Submittal of LRG-II Position Papers
and Summary of Outstanding Issues

LRG-II POSITION PAPERS

VOLUME VI

TECHNICAL DISCUSSIONS AND RESOLUTIONS OF SIX LRG-II ISSUES. THE POSITIONS TAKEN IN THESE PAPERS WILL BE REFERENCED IN LRG-II PLANT OL APPLICATIONS.

FIGURE 3-HFS

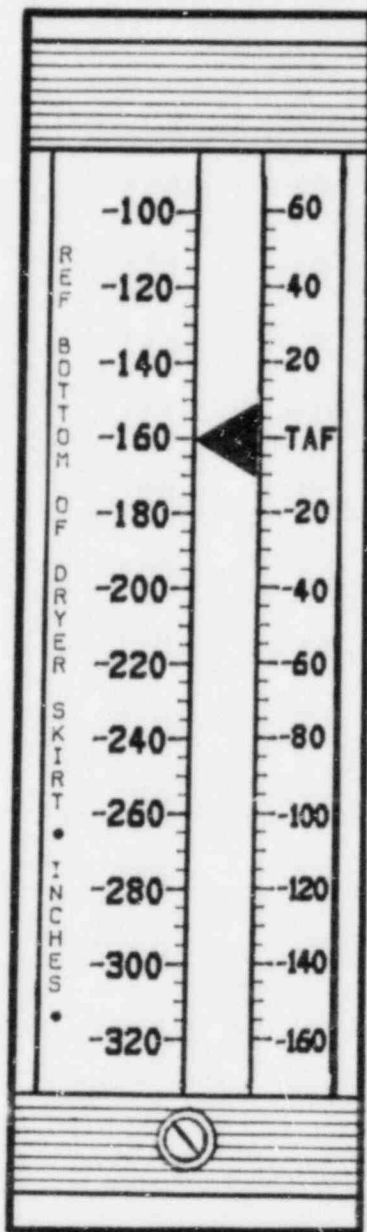
Provide a common reference level for all reactor water level instruments per the requirement contained in TMI Action Plan Item II.K.3.28.

The above evaluation was rejected by the NRC as explained in the letter from D. G. Eisenhut to D. B. Waters, dated April 6, 1981. In this letter, the NRC stated its position that "...all level

instruments should be referenced to the same point. The selection of the reference point for any specific reactor has been left to the discretion of the licensee..."

In light of this situation, LRG-II has taken the position to conform with the guidance contained in the above referenced April 6, 1981 letter and has selected the common reference point to be at the bottom of the steam dryer skirt. This reference point was the reference point used for all RPV level ranges except the fuel zone instruments.

The fuel zone instruments will have dual numerical scales with the left-hand scale readings corresponding to the common instrument zero plane and the right-hand scale readings corresponding to the classical BWR fuel calibration which is referenced to the top of active fuel. A life-size copy of the dual scales mounted on a GE Type 180 instrument is provided on Figure 3-HFS.

This dual indicating scale for the fuel zone instrumentation is not confusing to the operator because it is secondary to the numerical scale which indicates "common" water level information. However, this arrangement also retains for the operator ready reference to actual fuel zone levels. Appropriate training for the use of the dual scale reactor water level indicators, including upgrading of training and maintenance documents and procedures, will be accomplished prior to fuel loading.
